TECHNICAL BULLETIN

SCANIA BRAKE DRUM SC1021 DESIGN CHANGE

Original Equipment Part Numbers: 1361331, 1414153, 2109552, 2378715, 324878, 360571, 368269, 392386

SC1021
DRILLING PLAN VIEW

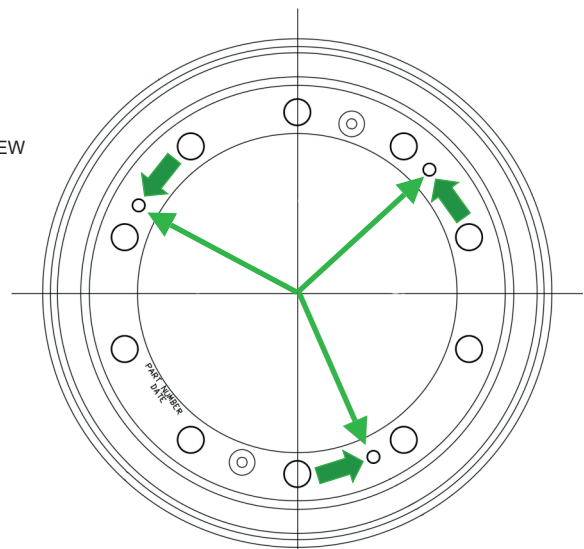
The three M12x1.75 threaded holes used to remove the brake drum from the hub have changed position.

OLD DRILLING POSITION

NEW DRILLING POSITION

SCANIA HUB DESIGN
ILLUSTRATION

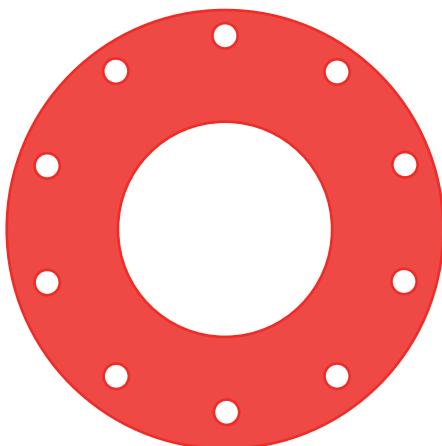
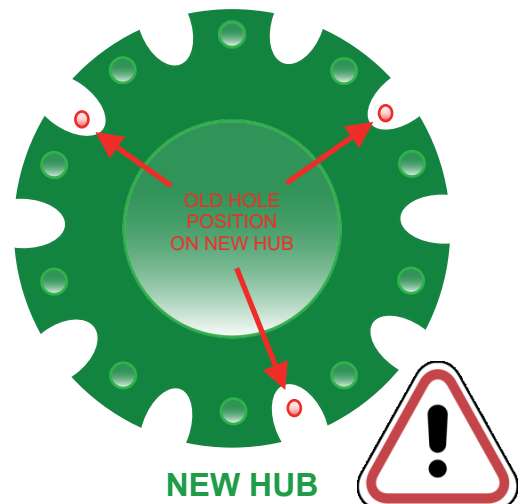
New hub design means that the central threaded holes would NOT engage with the hub when being removed.

OLD HUB

NEW HUB
